From: Detterman, Mark, Env. Health
Sent: Tuesday, June 28, 2011 10:35 AM
To: 'Kiernan, James'
Subject: FW: Chevron #9-7127 (Mountain House / Tracy / RO185) - Question

Figure 2
 SITE PLAN AND PROPOSED BORING AND WELL LOCATIONS
 FORMER CHEVRON SERVICE STATION 9-7127
 GRANT LINE ROAD AND INTERSTATE 580
 Tracy, California

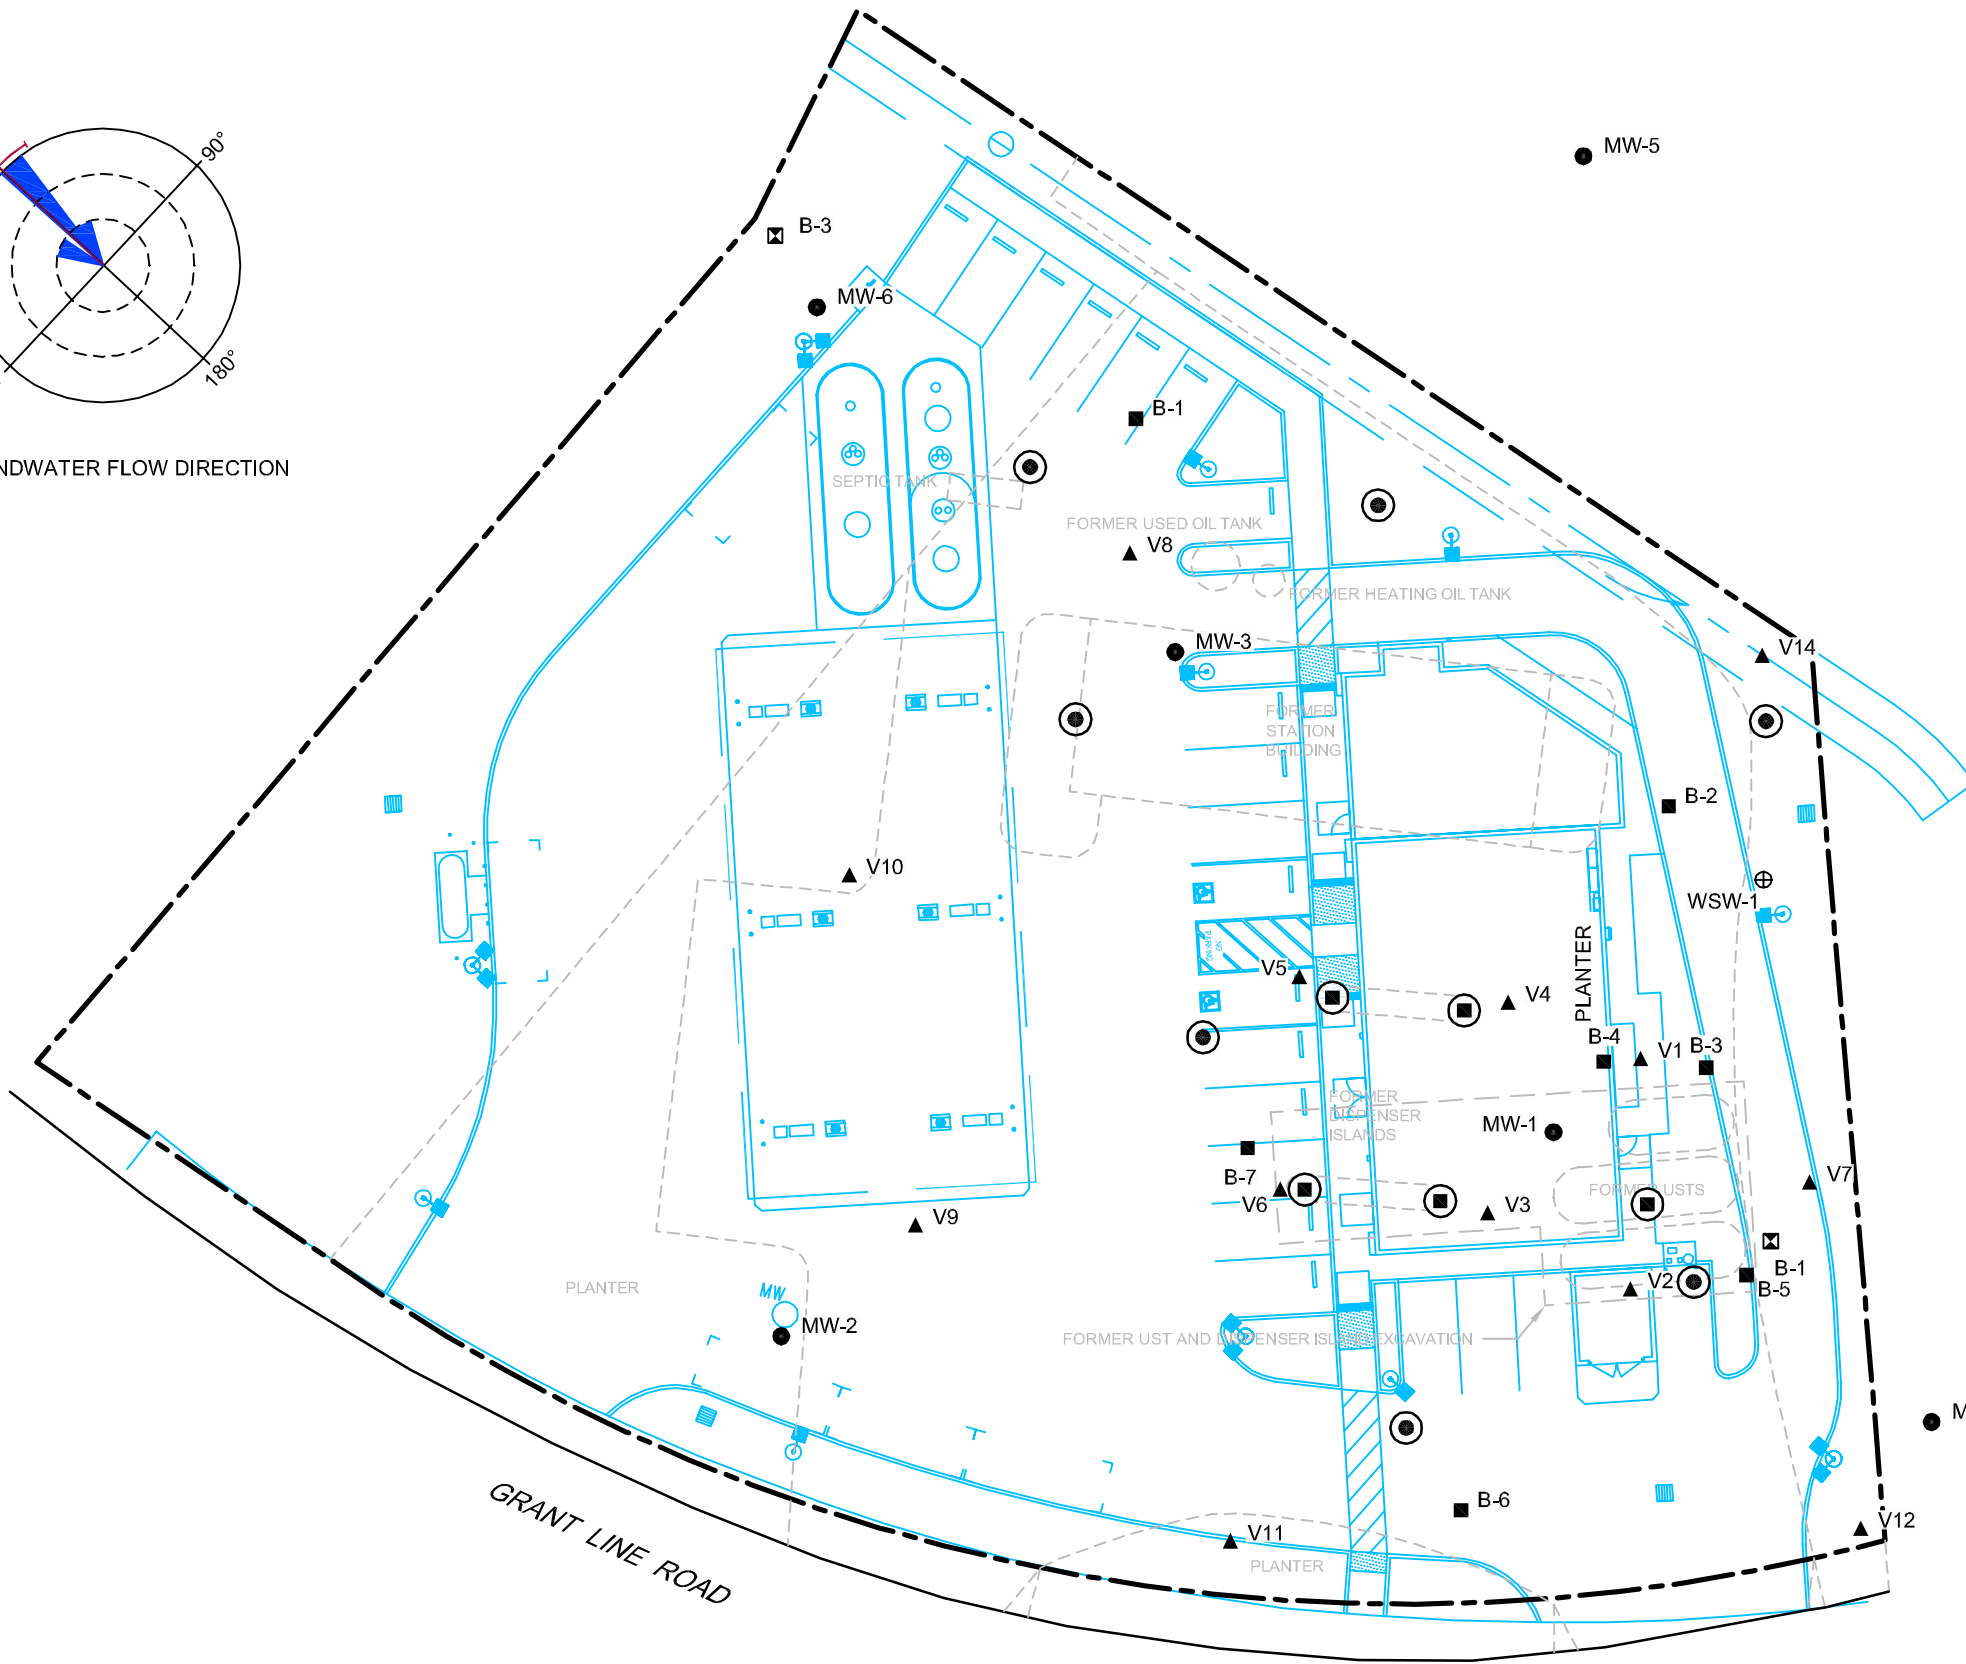
Per our telephone conversation just now, and provided there are no significant changes to well locations, the draft version of well location plan helps ACEH understand the intent of the well locations as commented on in the first Technical Comment of the April 27, 2011 DIR letter. Thanks for forwarding the draft figure. Although the WP was approved in the April letter, should there be doubts, please consider the work plan “fully” approved.

So what’s the purpose of the well near V14 at the SE corner of the site? Give me a call if you want to move it along quicker.

On Figure 2 the wells are placed to accommodate the future building per the report text; can you place the future building plans to allow that understanding?
